A303 Amesbury to Berwick Down

Deadline 7
8.45 - Errata Report

ERRATA Report

Regulation Number:	Regulation 5(2)(q)
Planning Inspectorate Scheme Reference	TR010025
Application Document Reference	8.45
Author:	A303 Amesbury to Berwick Down Project Team, Highways England

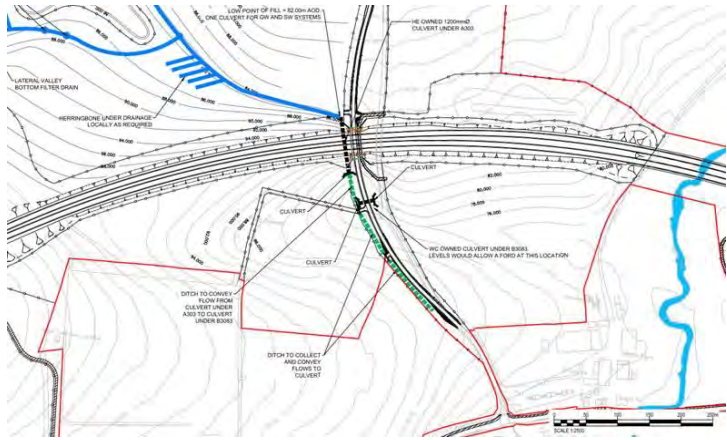
Document no.	Document name	Section and Paragraph Reference	Nature of Erratum and Explanation	Replacement Text
			change scenario.	
REP3-008	Deadline 3 Submission – 6.3 Environmental Statement Appendix 11.5 Level 3 Flood Risk Assessment	Fig 3.2 of Annex 1A	Figure 3.2 has a box describing a ford crossing of the B3083. There is no formal ford at this location and mention of it needs removing.	<p>Figure 3.2 of Annex 1A requires a correction relating to the text associated with the mention of the ford crossing. There is no ford crossing at this location.</p> <p>‘Before’ extract with incorrect text “levels would allow a ford at this location”:</p>  <p>The technical drawing shows a road crossing a watercourse. Key features include: <ul style="list-style-type: none"> LOW POINT OF FILL - 82.0m AOD ONE CULVERT FOR ON AND OFF SYSTEMS HEAVY DRAIN 120mm Ø CULVERT UNDER A&E LATERAL VALLET BOTTOM FILTER DRAIN HERRINGBONE UNDER DRAINAGE LOCALLY ACQUIRED CULVERT NO OWNED CULVERT UNDER B&S&S LEVELS WOULD ALLOW A FORD AT THIS LOCATION DITCH TO COLLECT AND CONVEY FLOW FROM CULVERT UNDER AND TO CULVERT UNDER B&S&S DITCH TO COLLECT AND CONVEY FLOW TO CULVERT SCALE 1:250 </p>

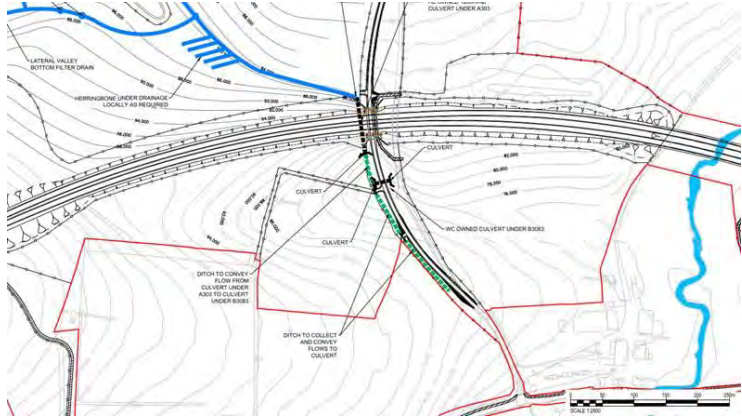
Document no.	Document name	Section and Paragraph Reference	Nature of Erratum and Explanation	Replacement Text
				<p>'After' extract without text:</p>  <p>The technical drawing is a plan view of a drainage system overlaid on a contour map. It features several key elements: <ul style="list-style-type: none"> LATERAL VALLEY BOTTOM FILTER DRAIN: A blue line representing a drainage channel at the top left. HERRINGTONS UNDER DRAINAGE: A series of parallel lines representing a drainage structure, with a note 'LOCALLY AS REQUIRED'. CULVERTS: Multiple structures labeled 'CULVERT' and 'CULVERT UNDER ROAD' crossing various features. DITCHES: Several ditches are shown, with labels such as 'DITCH TO COLLECT FLOW FROM CULVERT UNDER ROAD TO CULVERT UNDER ROAD' and 'DITCH TO COLLECT AND CONVEY FLOW TO CULVERT'. CONTOUR MAP: The background consists of grey contour lines indicating elevation. SCALE BAR: A scale bar is located at the bottom right of the drawing. </p>

Drawing Title
FIGURE 13.2 EXISTING PUBLIC RIGHTS OF WAY

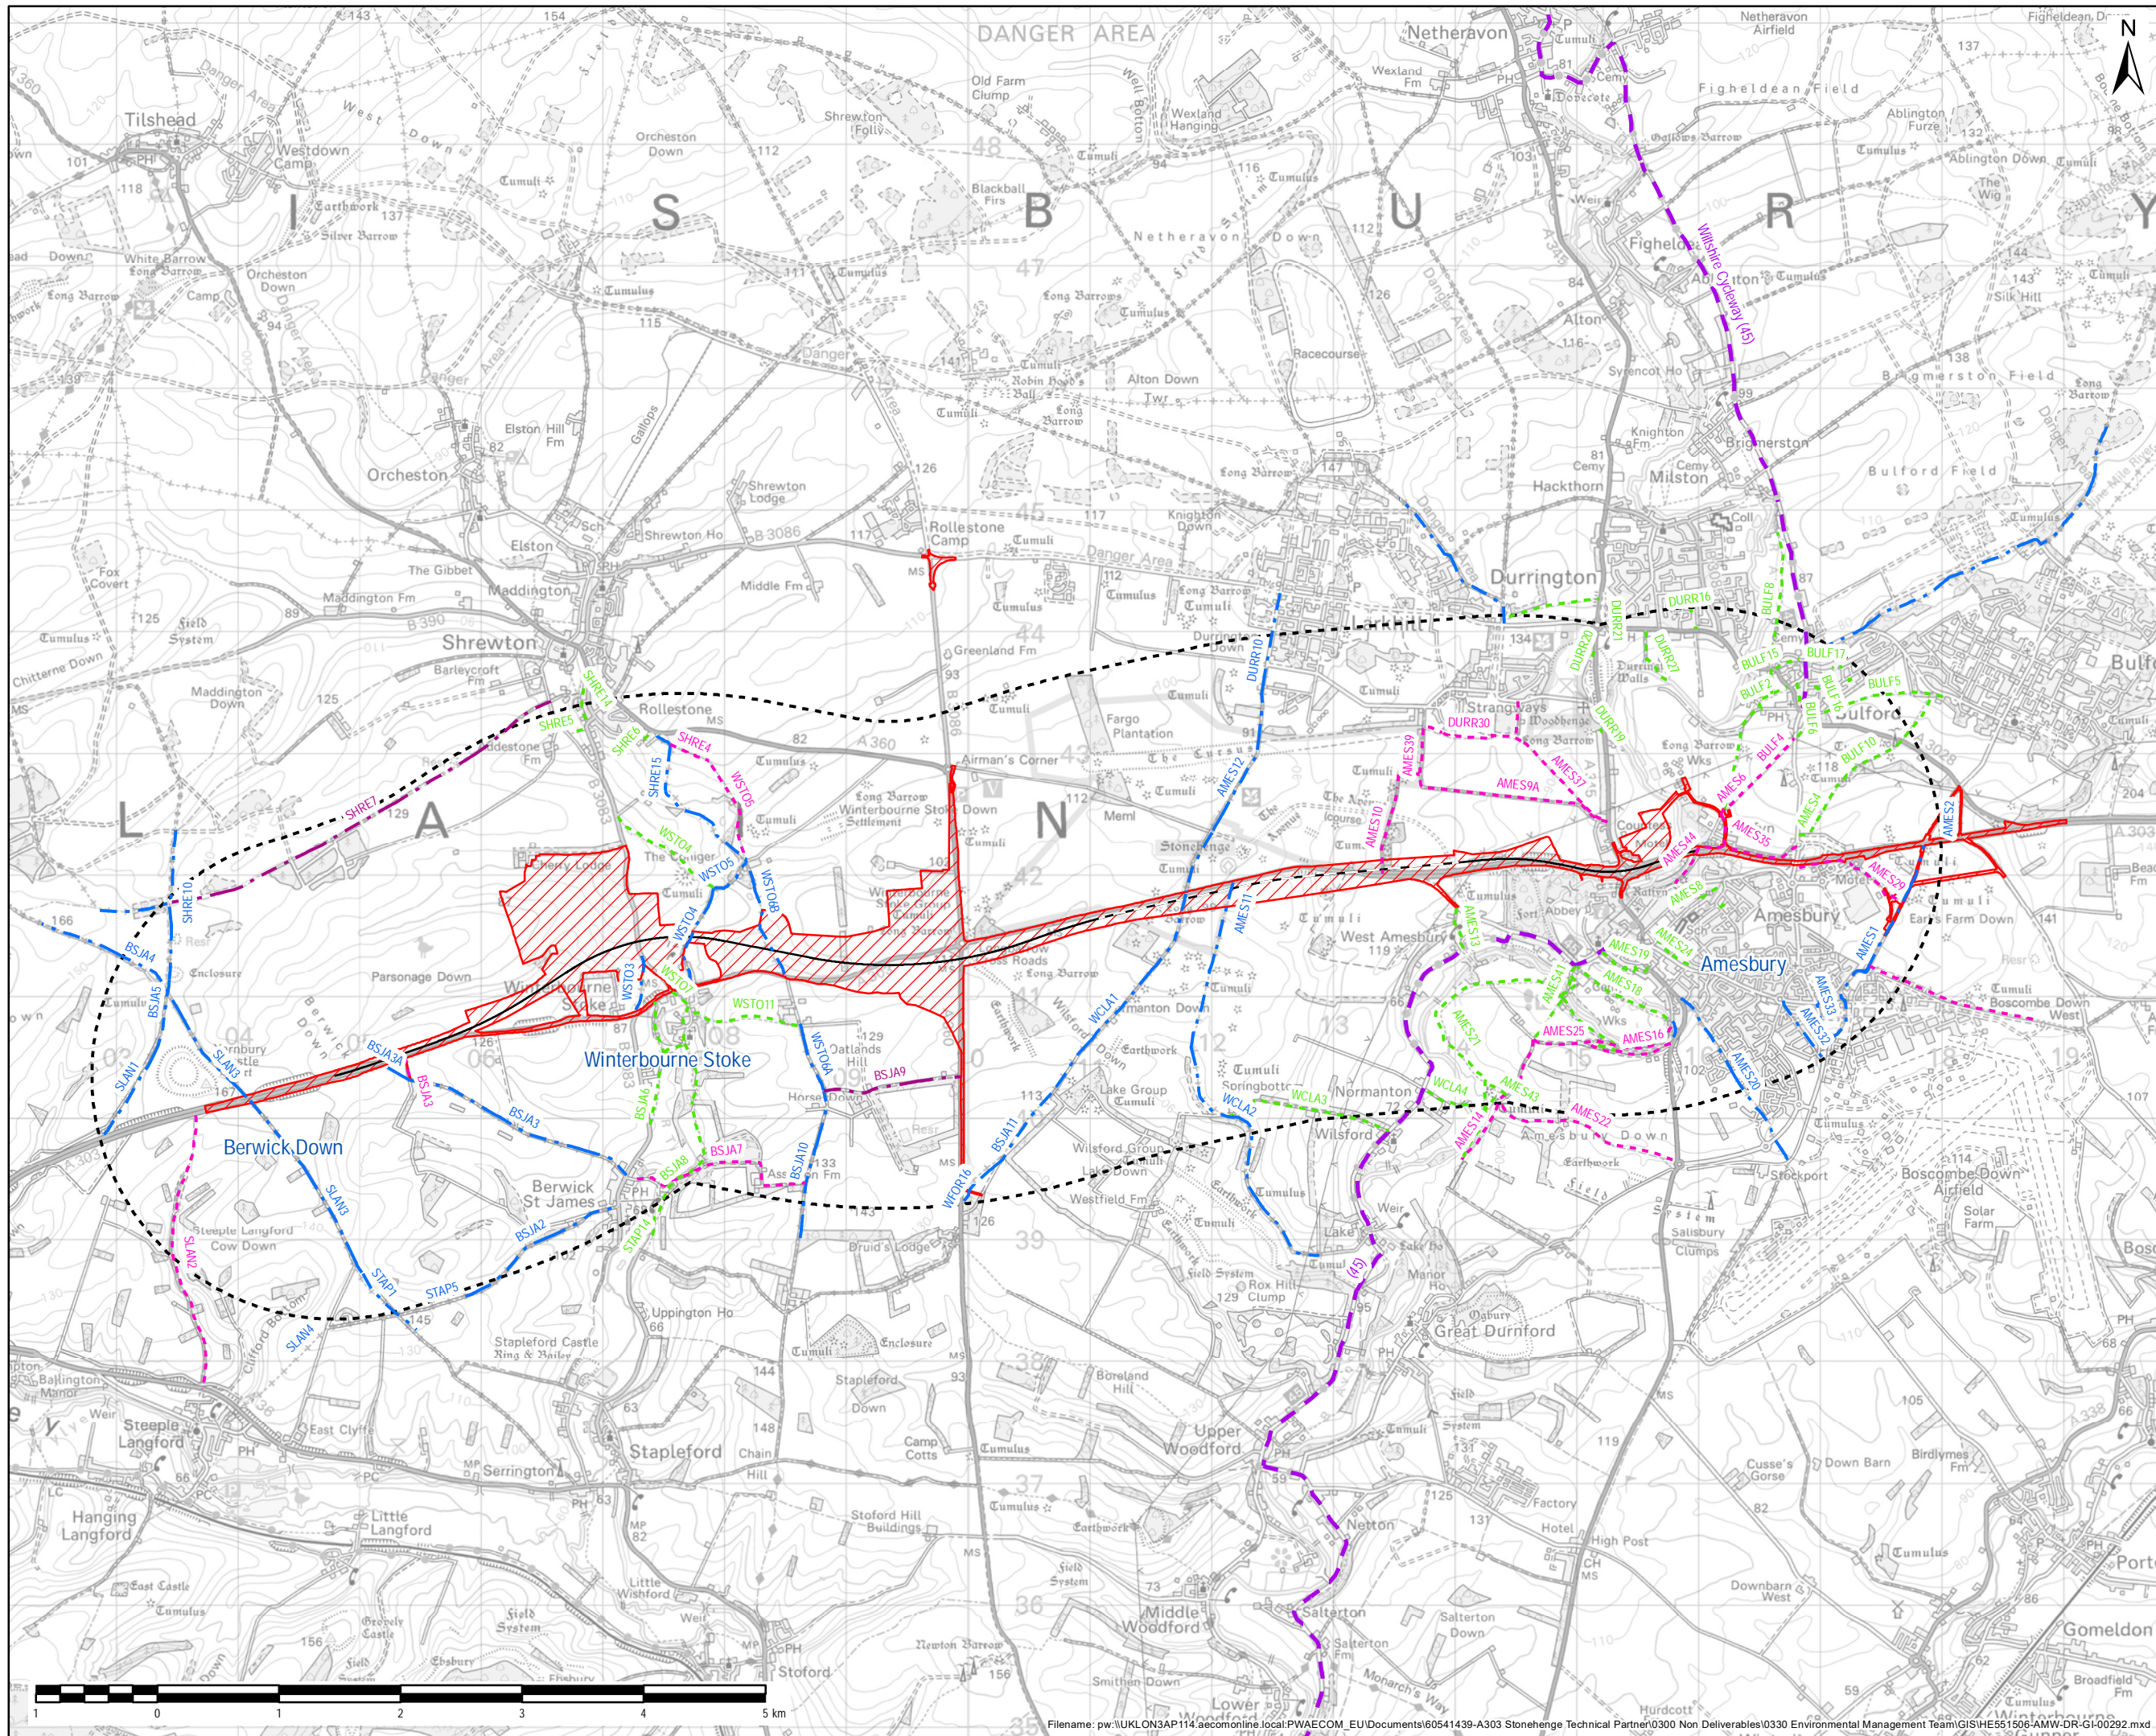
Document no.	Document name	Section and Paragraph Reference	Nature of Erratum and Explanation	Replacement Text
APP-180	ES Chapter 13	Figure 13.2	Error in Figure title	<p>The title of the Figure should be amended as shown:</p> <p>“FIGURE 13.2 EXISTING NMU ROUTES PUBLIC RIGHTS OF WAY”.</p> <p>The corrected figure is provided in Appendix A of this Report.</p>
APP-181	ES Chapter 13	Figure 13.3 A and B	Error in Figures	<p>The title of the Figure should be amended as shown: “FIGURE 13.3A EXISTING NMU ROUTES PUBLIC RIGHTS OF WAY”.</p> <p>The title of the Figure should be amended as shown: “FIGURE 13.3B EXISTING NMU ROUTES PUBLIC RIGHTS OF WAY”.</p> <p>The following errors as shown within the extracts below have been identified in Figures 13.3A and 13.3B. The corrected figures are provided within Appendix A of this Report. To confirm, these are drafting errors only and do not affect the conclusions of the assessment presented within Chapter 13 of the ES.</p>

Appendix A - Corrected Figure 13.2 and Figure 13.3
